**Lattice QCD Computing Project (LQCD)**

**Response to Recommendations  
from the  
2007 Annual Progress Review of the LQCD Computing Project**

May 7, 2008

Figure 1. Comparison of the interaction measure  $I = \epsilon - 3p$  using the Asqtad and P4 formulations of lattice quarks by the HotQCD Collaboration.

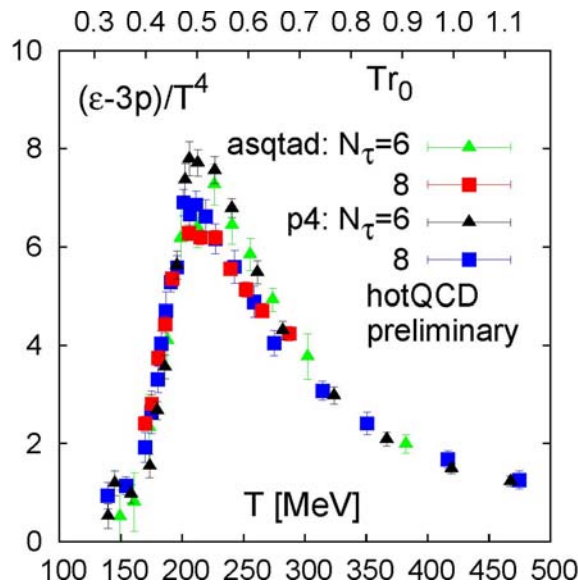
*"While the importance of validation between different fermion methods was emphasized by the presenters, we would like to see a clearer outline on how the comparison will be carried*

out. What will be compared, to what precision can this be done, and what will be learned from the comparison?”

**Response:** There are two important, but closely related, reasons for comparing results from different fermion methods:

- 1) To demonstrate that one does have full control over systematic errors, some of which are expected to differ among the fermion methods.
- 2) To add confidence to the determination of quantities that are particularly important for the experimental programs in high energy and nuclear physics. This would be especially important if one obtained results that were not in agreement with experiment.

Since different fermion formulations have different lattice artifacts, it is necessary to make comparisons in the continuum limit.

Among the quantities currently being calculated with more than one fermion method are the leptonic decay constants of the  $\pi$ , K, D,  $D_s$ , B and  $B_s$  mesons, the  $K^0 - \bar{K}^0$  mixing parameter  $B_K$ , the quark masses  $m_l = (m_u + m_d)/2$ , and  $m_s$ , the low energy constants of the chiral lagrangian, the heavy quark potential parameters  $r_0$  and  $r_1$ , hadron structure observables, the equation of state for high temperature QCD, and the cross-over temperature between ordinary hadronic matter and the quark-gluon plasma. The accuracy with which the comparisons will be carried out in the next few years depends on the quantity being studied, ranging from the percent level for the leptonic decay constants of the  $\pi$  and K mesons, to the five percent level for equation of state and cross-over temperature.
